MANUAL CHANGES

MANUAL IDENTIFICATION

Model Number: 141T
 Date Printed: June 1976
 Part Number: 00141-90914

Figure 1. Component Identification, Power Supply A2

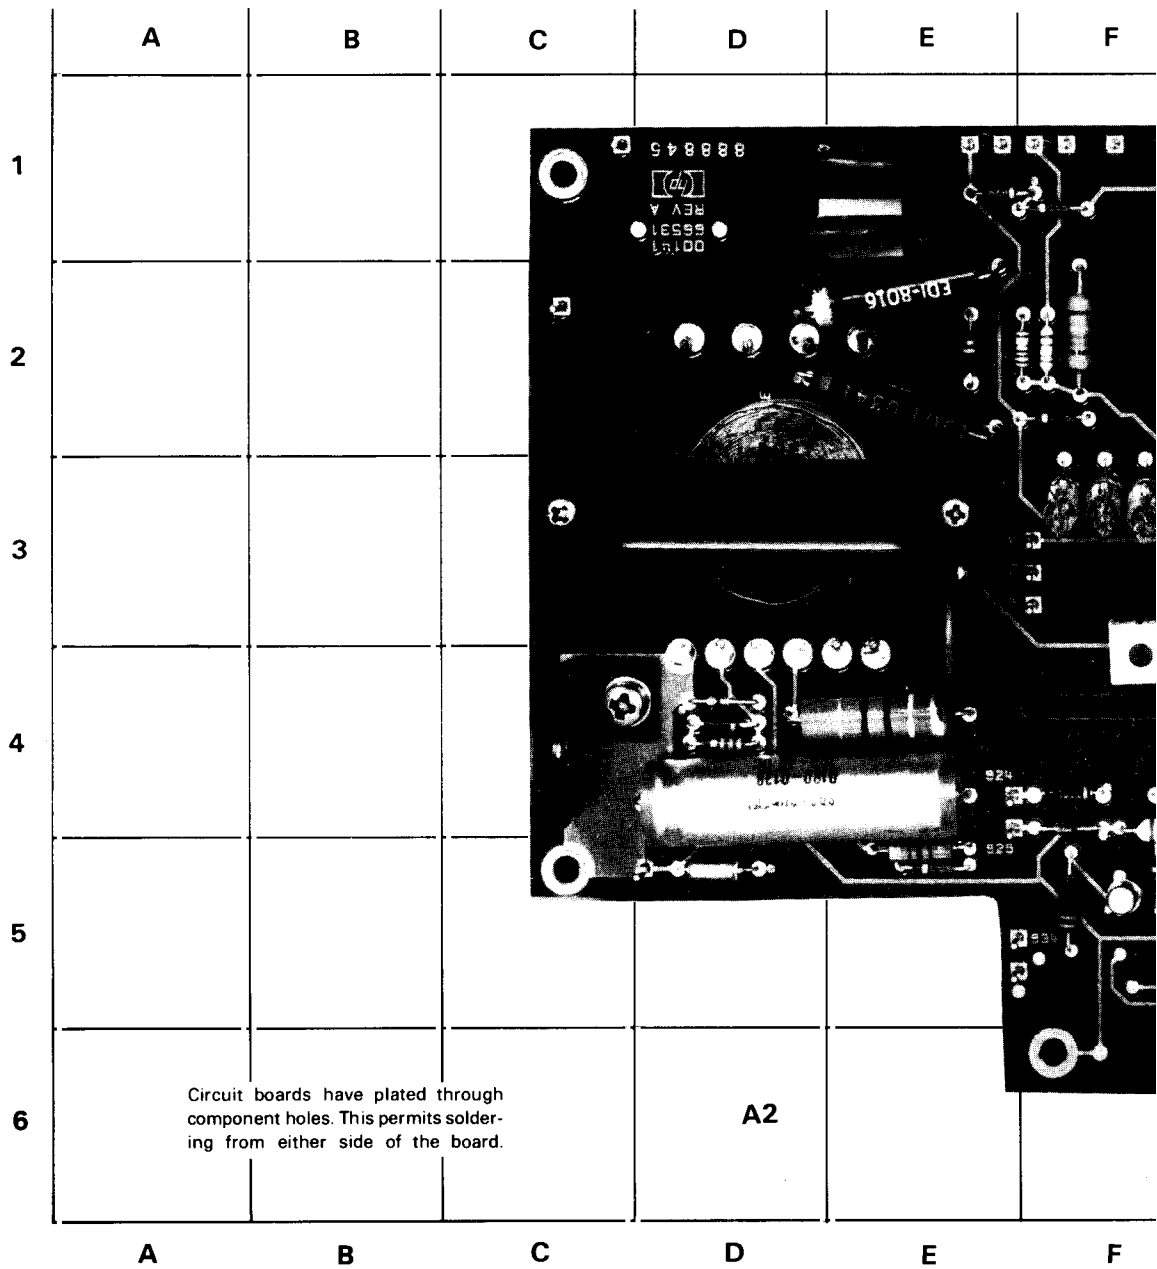
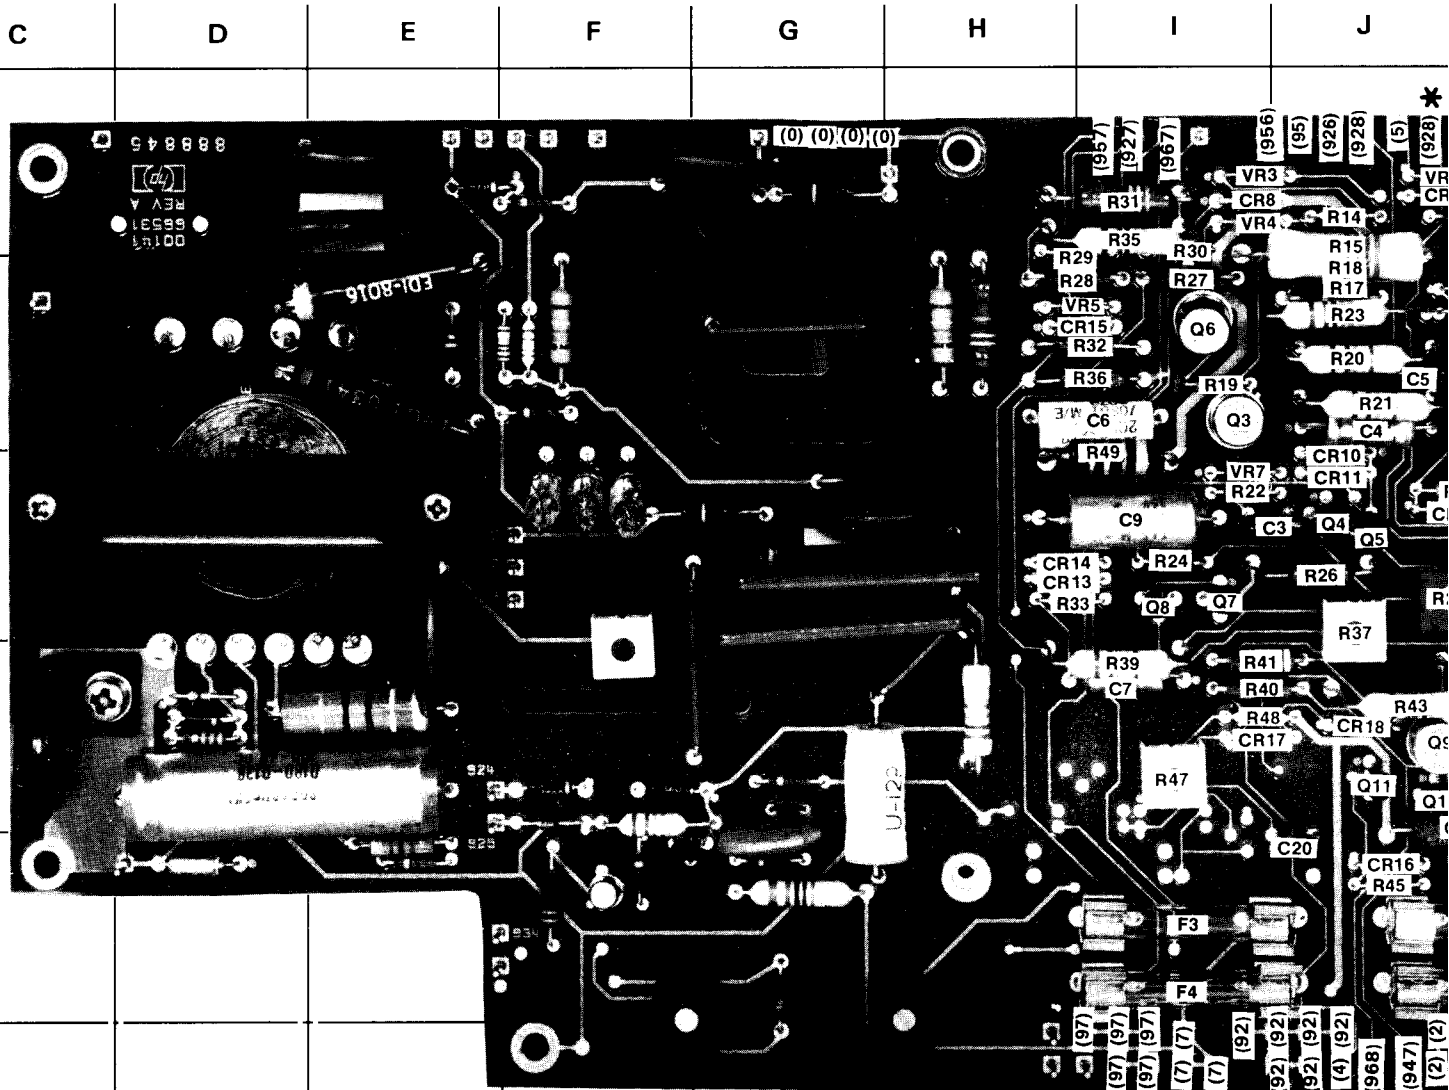
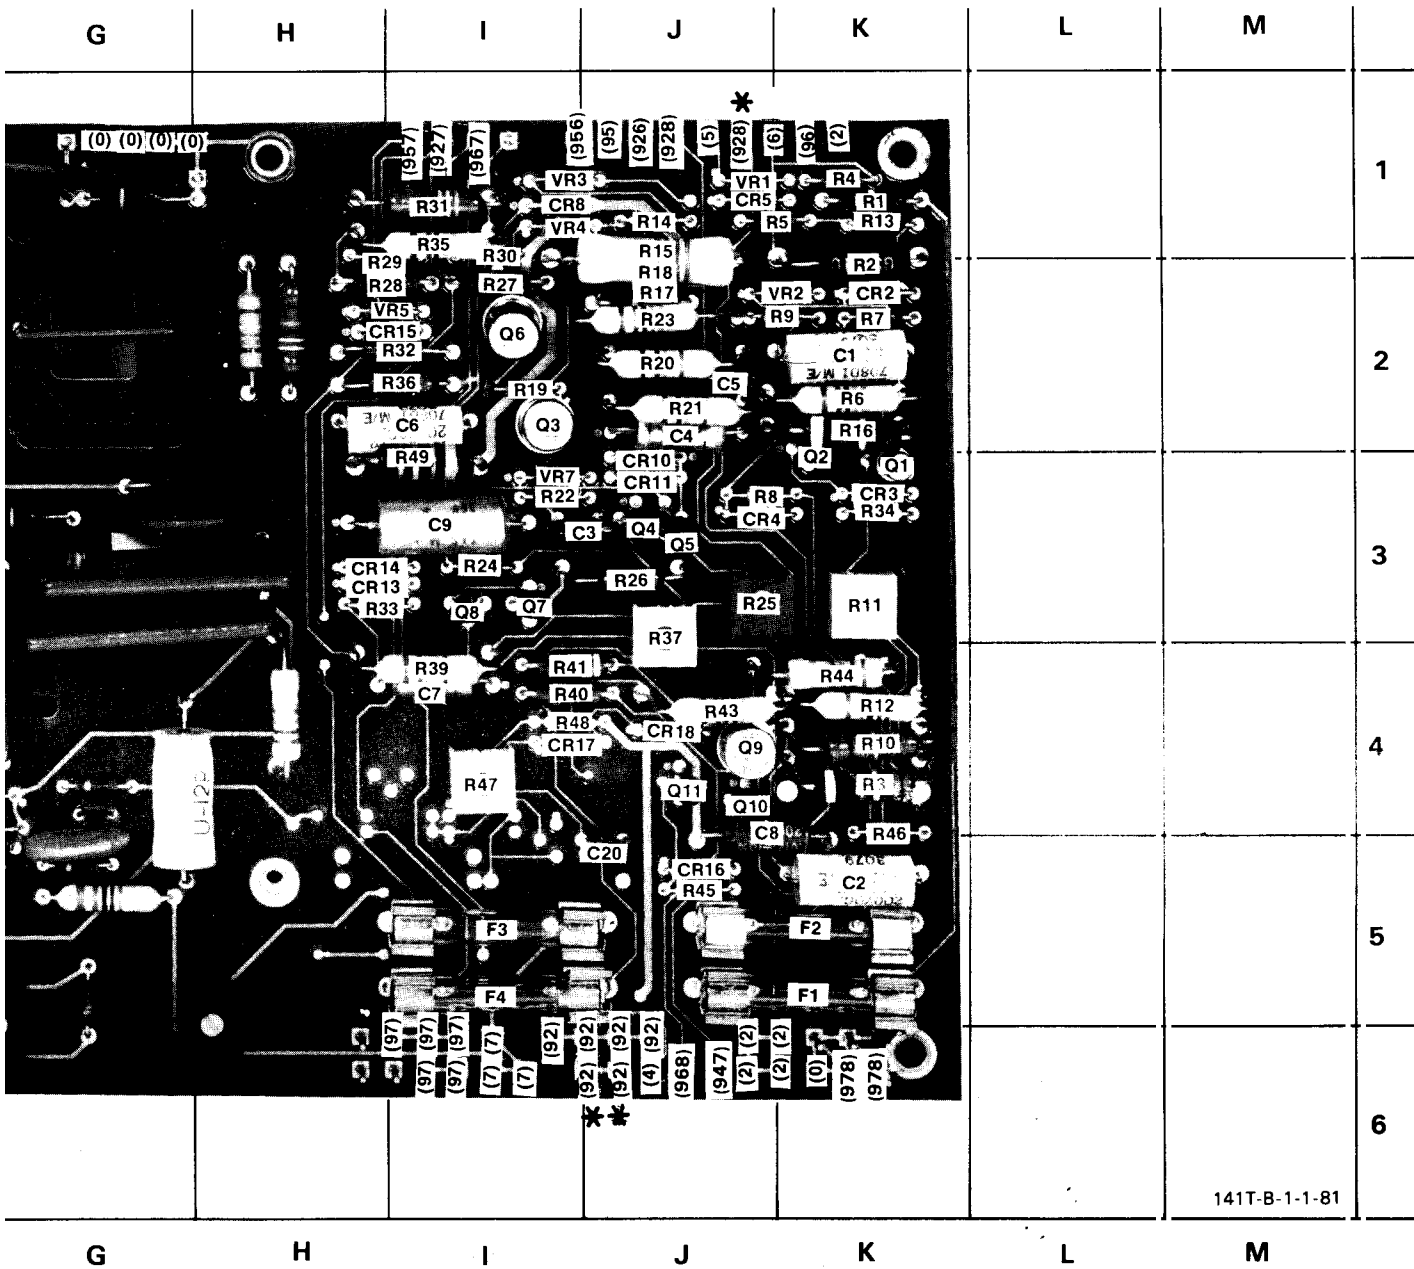
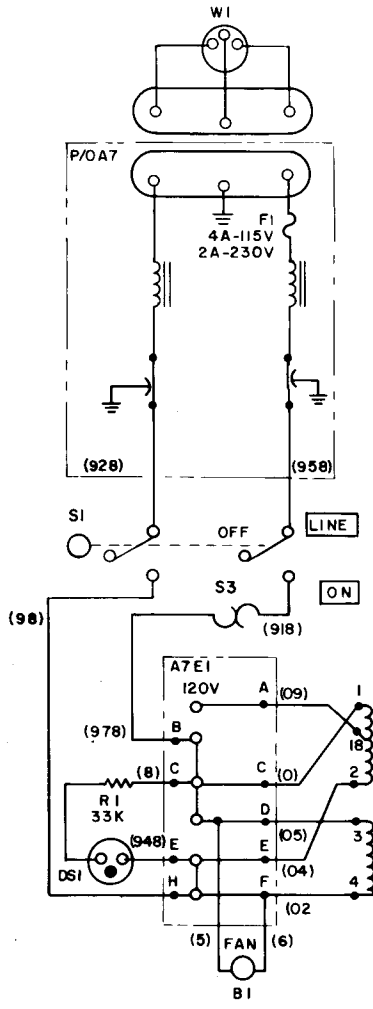
Refer to Figure 1 of this document for location of power supply, intensity, and geometry adjustments.

Figure 8-8. Component Identification, Power Supply A2 (page 8-14),

Replace with Figure 1 of this document.
